Subject: City of Republic Standard Specifications

The following narrative provides a guide to the revisions made in response to MDNR review of the Construction Specifications for Public Improvements for the City of Republic. The numbering format matches comments/issues conveyed in the June 18, 2014 correspondence from Byron Shaw, SRF Engineering Unit Chief in the Financial Assistance Center.

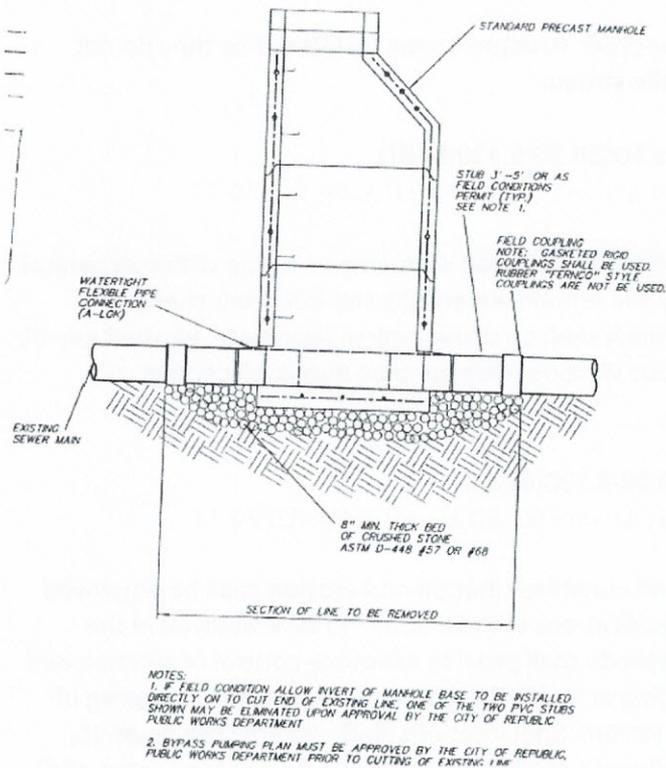
a. Doghouse manhole – Our experience is that doghouse manholes quickly develop I&I problems due to concrete/grout not bonding to PVC and also due to differential settlement. In these situations, we require a section of the existing pipe to be removed, a precast base set to grade and then piping is reconnected using rigid fittings, an example is shown to the left.
